Stannah Lifts Newsletter for Site Personnel.

Issue 9 March 2000

Rationalisation of Ram Support Brackets (System21).

0004660 Cornice Lamp Assmbly

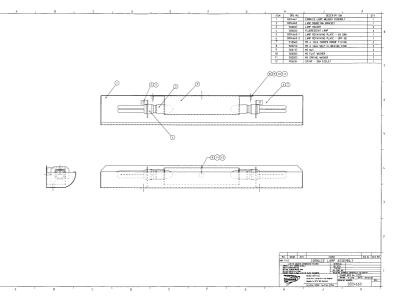
New light design requires a TX25 tool bit to secure bulbs.

The cornice light assembly on the Piccolo and Maxi M lifts, up to 10 person, has been modified to meet the minimum light levels of 50 lux at floor level as specified in BS EN 81-2.

Please be advised that this new design now uses tamperproof fixings to retain the light bulbs. This means that a TX25 security torx tool bit will be required to replace a bulb. (RS ref. No. 736-210).
